Technical Service Bulletin

26 Droning, buzzing, or vibration from front of the vehicle

26 20 36 2054935/3 February 12, 2020. Supersedes Technical Service Bulletin Group 26 number 19-35 dated June 13, 2019 for reasons listed below.

Model(s)	Year	VIN Range	Vehicle-Specific Equipment
Q7	2017 - 2018	All	3.0TFSI
Q7	2019	000001 - 023479	3.0TFSI

Figure 1. Exhaust hanger “A” and decoupling element “B”.

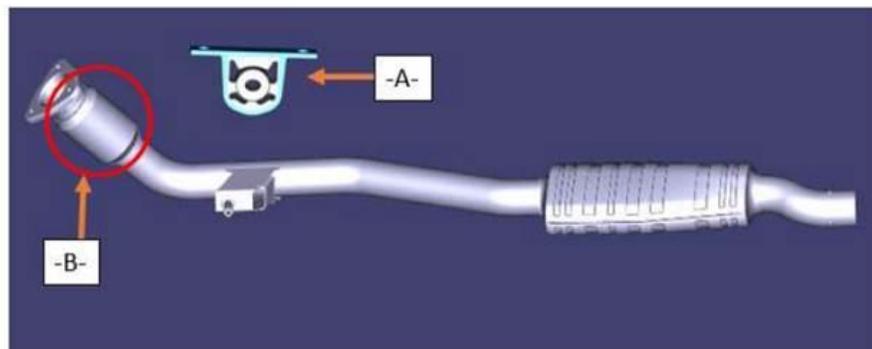
Over time, the exhaust decoupling element may become worn and ineffective.

Vehicles in production receive improved exhaust hangers to reduce NVH. These parts are now available in service.

1. Verify exhaust downpipes as the source of the customer concern.
2. Replace both exhaust downpipes (“exhaust pipe with exhaust muffler, front”) and exhaust hangers (“bracket for exhaust pipe”) with the part numbers outlined below (or any future supersession thereof).
3. Test drive vehicle to verify that the concern is no longer present.
